Access Compliance Report

Public Rights-of-Way (Curb Ramps)

Intersection ID: 10756	Main Street: GALWAY_DR	Cross Street: SHANNONHOUSE_DR	Location: NW
ADA ID: B00CCDF52B80	Ramp Type: Perp	Initial Pass/Fail: Pass	Overall Compliance: No
		Severity Score: 7.5

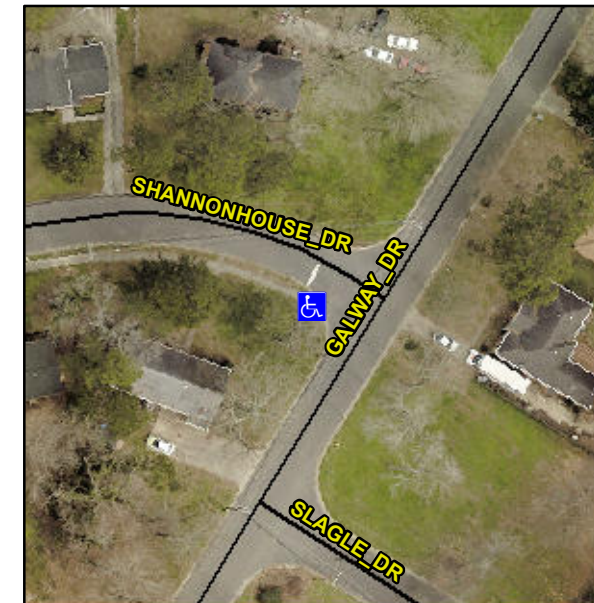
**Not Found, R304.2.1, R304.2.2-Perp,
R304.3.2-Para, R305.1.4, R305.2,
R304.5.4**

Compliance	Description	Data	Compliance	Description	Data
N/A	Ramp Length (in)	63.0	Yes	Ramp Slope (%)	5.6
Yes	Ramp Width (in)	52.0	Yes	Ramp XSlope (%)	1.9
N/A	Flare Type LT	None	N/A	Flare Type RT	N/A
N/A	Flare Slope LT (%)	N/A	Yes	Flare Slope RT (%)	6.5
N/A	Flare Traversable LT?	N/A	N/A	Flare Traversable RT?	Yes
No	Landing Length (in)	33.0	Yes	DWS Provided?	Yes
Yes	Landing Width (in)	49.0	Yes	DWS Contrast?	Yes
No	Landing Slope (%)	3.5	Yes	DWS Length (in)	24.0
Yes	Landing X Slope (%)	0.2	No	DWS Full Width?	No
N/A	Landing Curb? (Y/N)	No	No	DWS Offset (in)	4.0
N/A	Shared Landing?	No			
Yes	Gutter Ponding?	No	No	Gutter Slope (%)	5.7
Yes	Gutter Lip Ht (in)	0.0	Yes	Gutter X Slope (%)	1.1
N/A	Painted X Walk1?	No	N/A	Painted X Walk2?	N/A
	X Walk 1 Direction	To NE		X Walk 2 Direction	N/A
N/A	X Walk 1 Width (in)	N/A	N/A	X Walk 2 Width (in)	N/A
	X Walk 1 Slope (%)	0.2		X Walk 2 Slope (%)	N/A
	X Walk 1 X Slope (%)	3.7		X Walk 2 X Slope (%)	N/A

N/A	Ramp inside XWalk1?	N/A	N/A	Ramp inside XWalk2?	N/A
	Road Slope (%)	N/A	N/A	Clear Space?	Yes
	Road X Slope (%)	N/A	N/A	Clear Space to XWalk (in)	N/A
Yes	Any Obstructions?	No	Yes	Storm Grate/Utility Hazard?	No
	Obstruction Type			Storm Grate/Utility Type	
		N/A			N/A
			Yes	Surface Condition? (G/P)	Good

**Remove & Replace Entire Ramp.
Remove & Replace Gutter.**
